Comments on Tentative Order No. R9-2012-0011

Laura Coley Eisenberg, VP – Open Space & Resource Management, Rancho Mission Viejo

August 22, 2012

SAMP Terrains/Geomorphology Principle

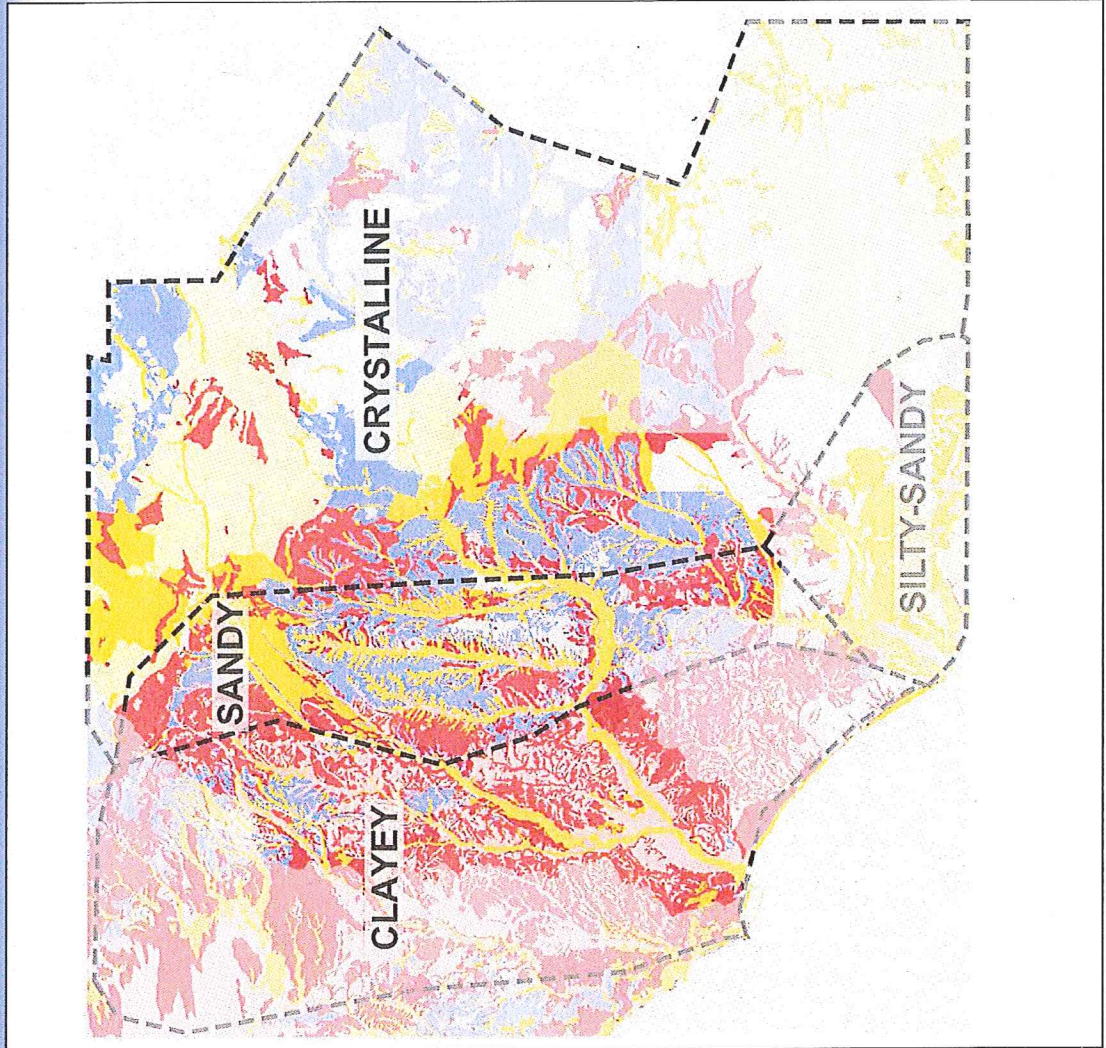
- **Principle: Recognize and account for the hydrologic response of different terrains at the sub-basin and watershed scale.**

■ **Application of the Terrains/Geomorphology Principle at the watershed scale resulted in concentration of development in clay/silt terrains while protecting sandy, high infiltrating terrains. This resulted in the following water quality benefits:**

- maximizing infiltration over the watershed,
- minimizing the pre and post project change in runoff; and
- protecting sources of coarse sediment important for stream course functions, aquatic habitat and beach sand replenishment.

SAMP Buffer Tenet

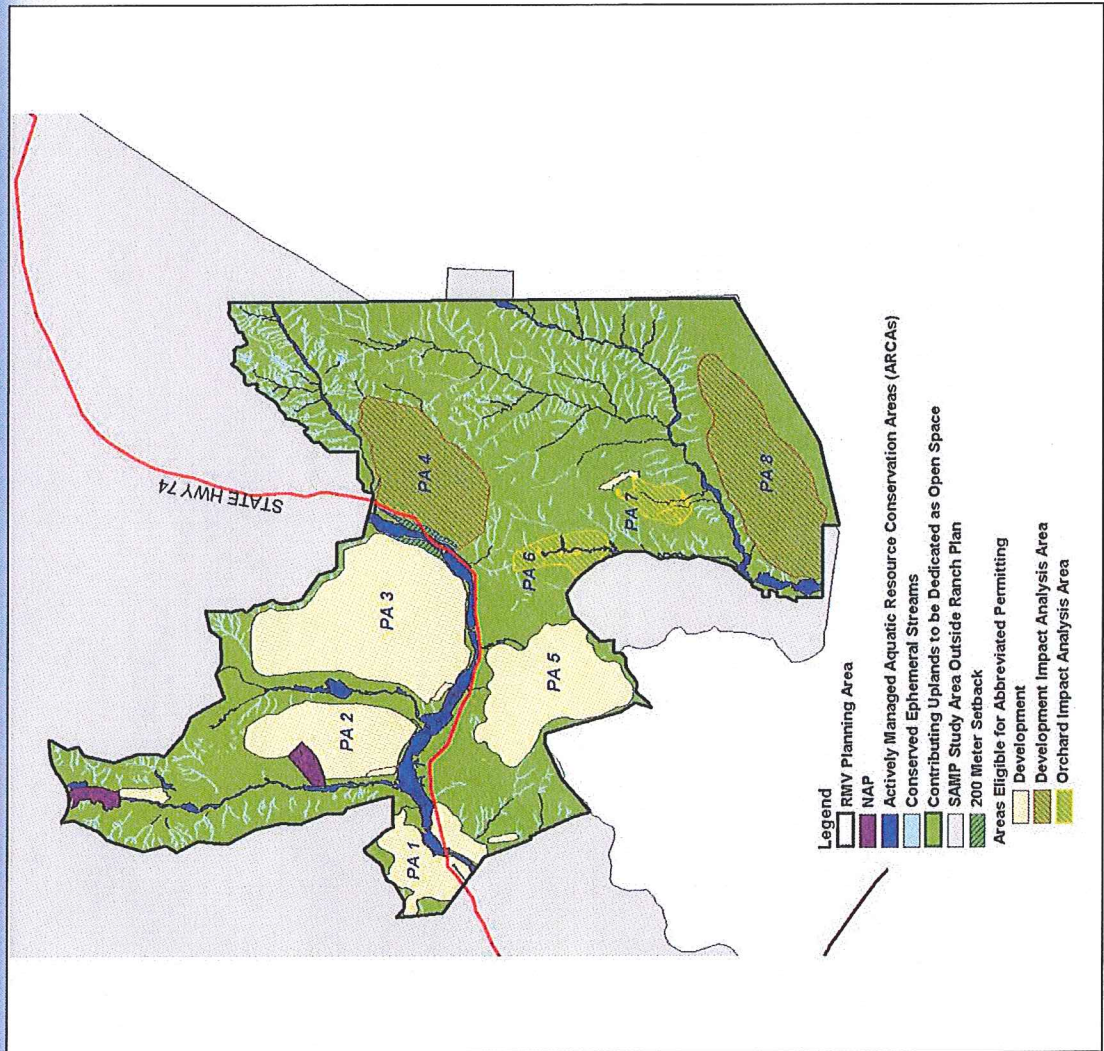
- **Tenet: Maintain adequate buffer for the protected riparian corridors**

- Application of the Buffers Tenet at the watershed scale has resulted in protection of all mainstem creeks on RMV and protection of over 1,650 acres of riparian habitats within the RMV portion of the Southern Subregion Habitat Reserve.
